**Alex Avenue Public School – State Significant Development – Application Number SSD\_9368 (“SSD\_9368”)**

We refer to the modification application (being modification no. 4) pursuant section 4.55(1A) of the *Environmental Planning and Assessment Act 1979* (NSW) (“**EP&A Act**”) being sought by the Department of Education (“**DoE**”) to modify SSD\_9368 in relation to the Alex Avenue / Galungara Public School (“**MOD 4**”).

We are instructed to raise a formal objection and make submissions in relation to MOD 4 on behalf of our client the particulars of which are set out below.

**LEGEND**

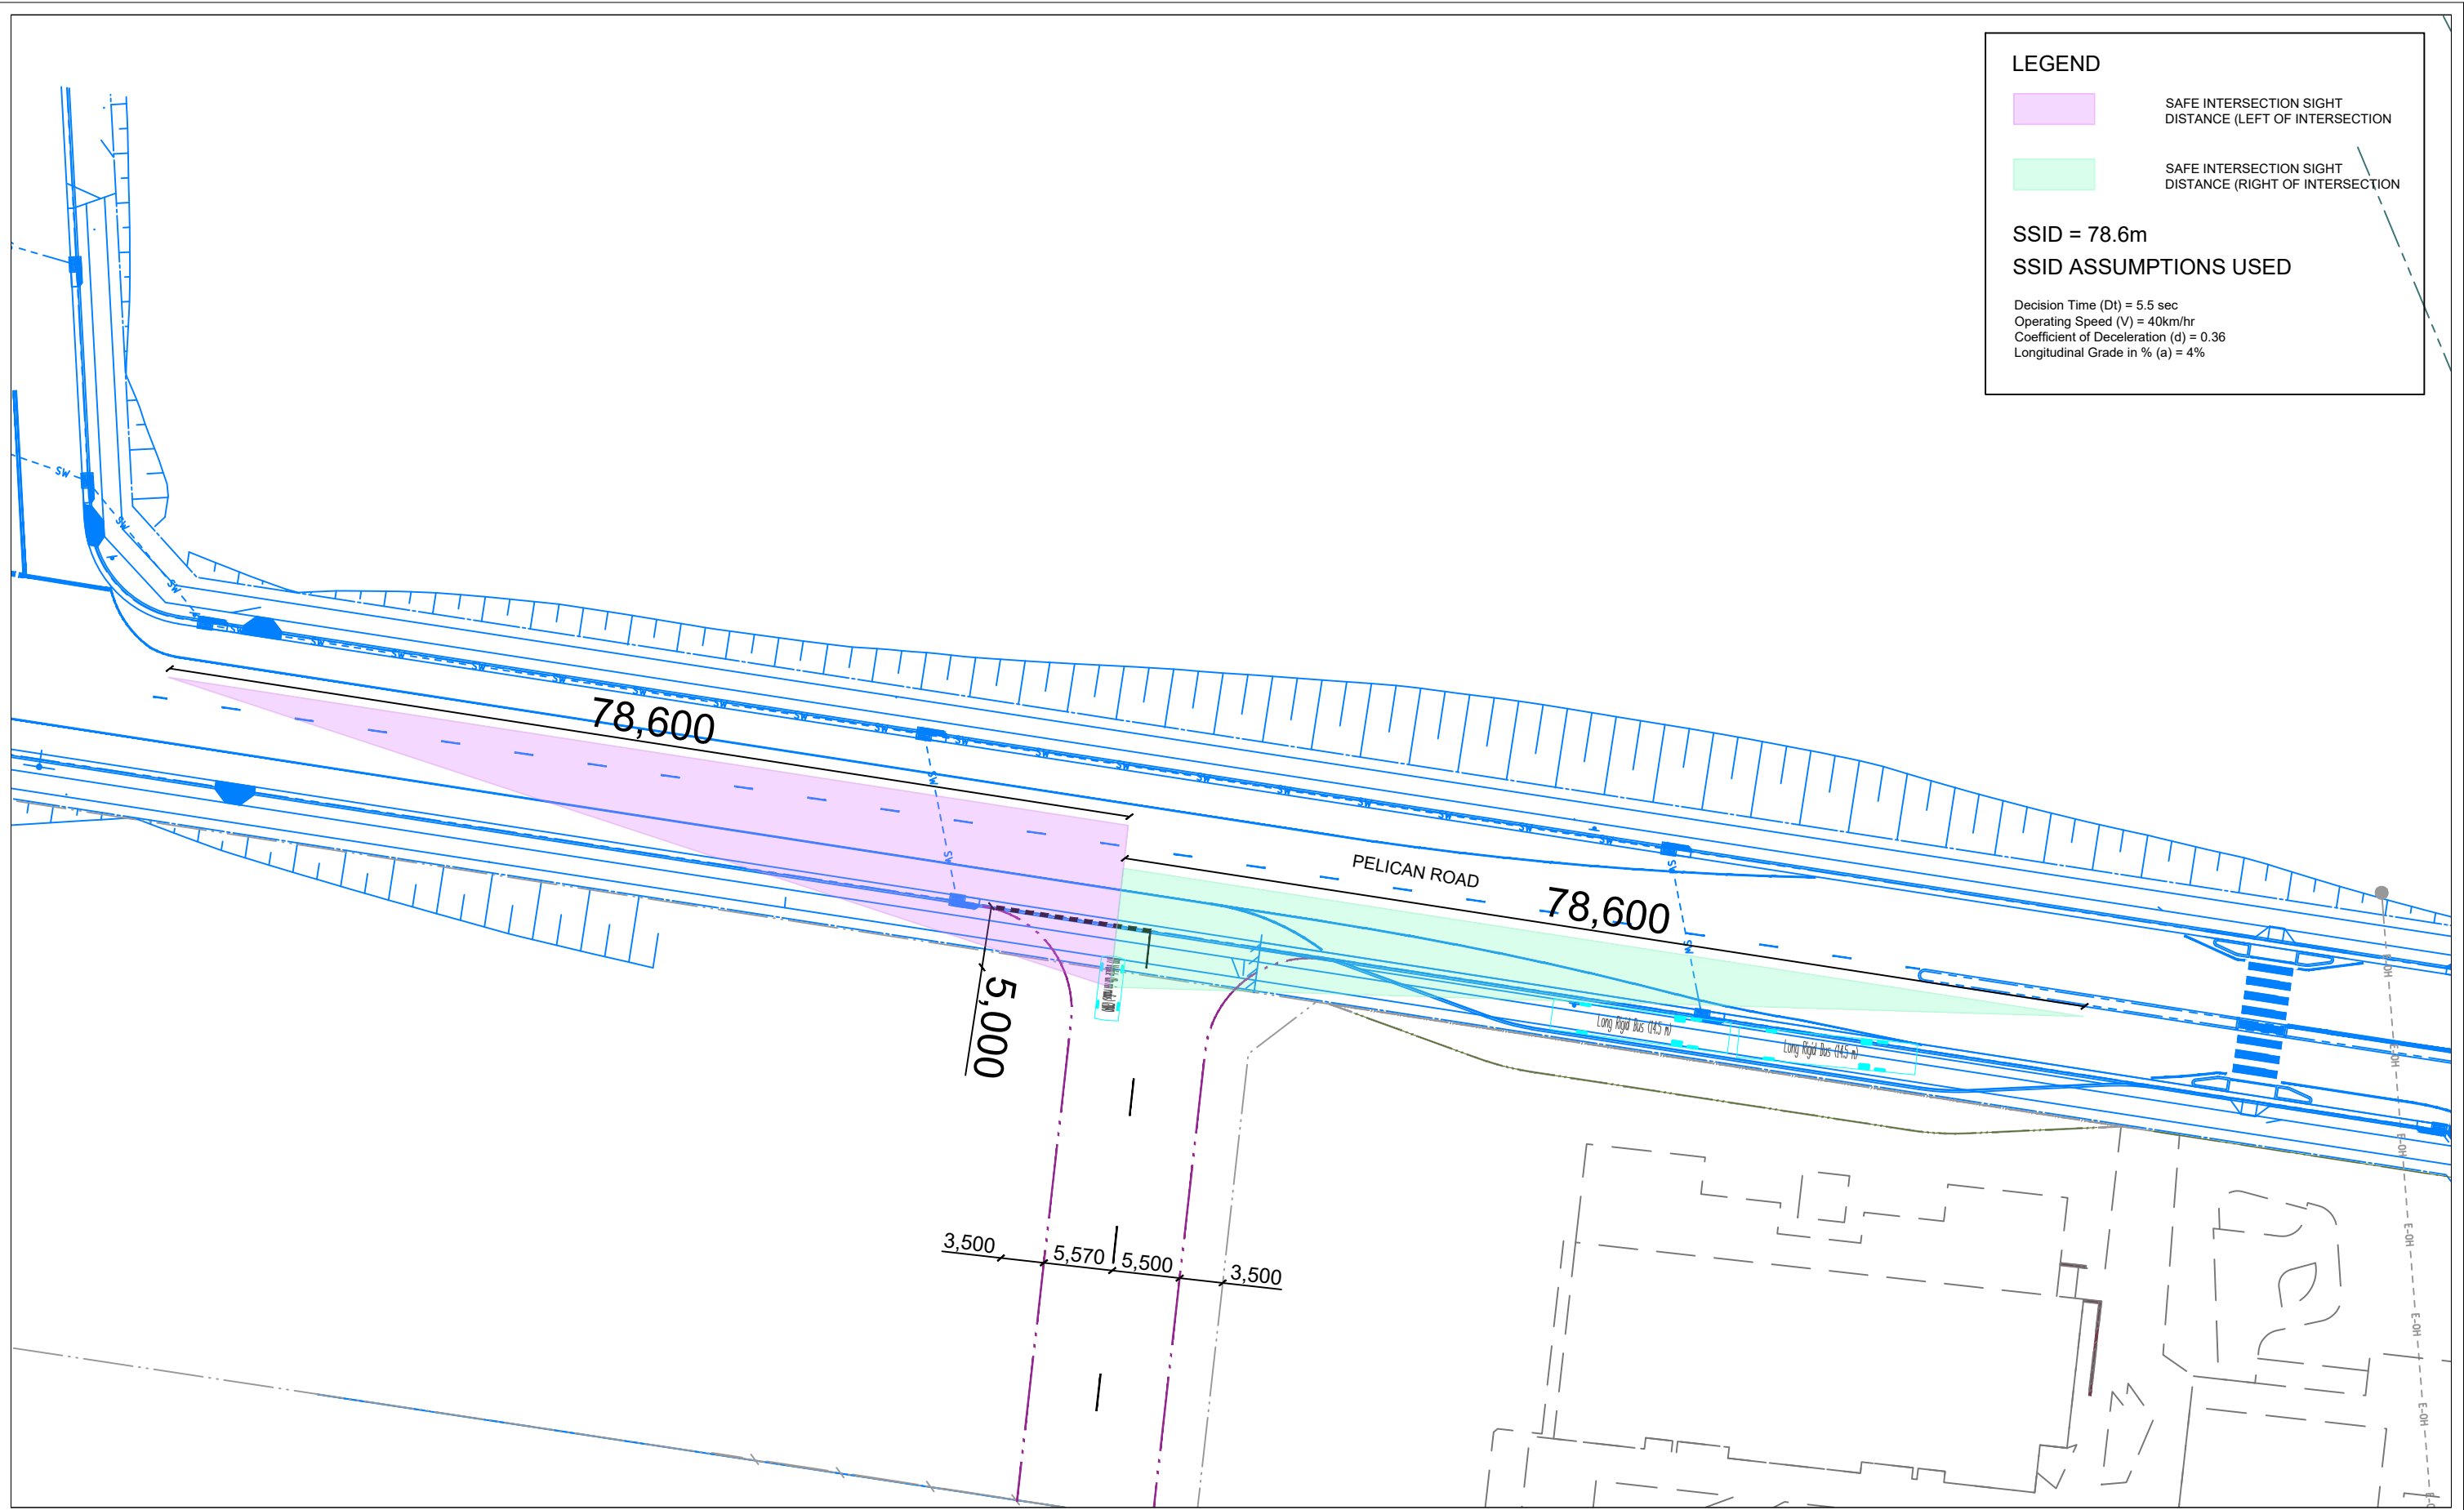
*"The outcome of that sightline assessment was provided on Sheet 02 of 10 attached to the GTA letter and is reproduced in the following pages, revealing that the sightlines required to achieve safe intersection sight distance in accordance with Austroads was 160.5m. Significantly however, **the GTA sightline assessment did not take into account the proposed bus bay which is illustrated on Sheet 03 of 10 in the GTA letter (also reproduced in the following pages) which has now been approved under SSD 9368.**"*

*If analysis exists which shows a sightline assessment that does take into account the proposed bus bay, please provide us with a copy of that analysis. If such analysis does not exist, please confirm this is the case.*

A revised SISD assessment has been completed based on approved Northrop Civil Design Drawings (which incorporates the approved Toplace road construction drawings) based on three scenarios:

As identified previously in GTA's assessment, the indented bus bay are for school bus use only. Further consultation undertaken with the local bus operator and TfNSW further confirmed that if a school bus is to be introduced, the school bus will only access the bus bay during the AM drop off and PM pick up period as part of a modified, linked public transport route. Buses are typically not expected to dwell within the indented bus bays for extended periods of time.
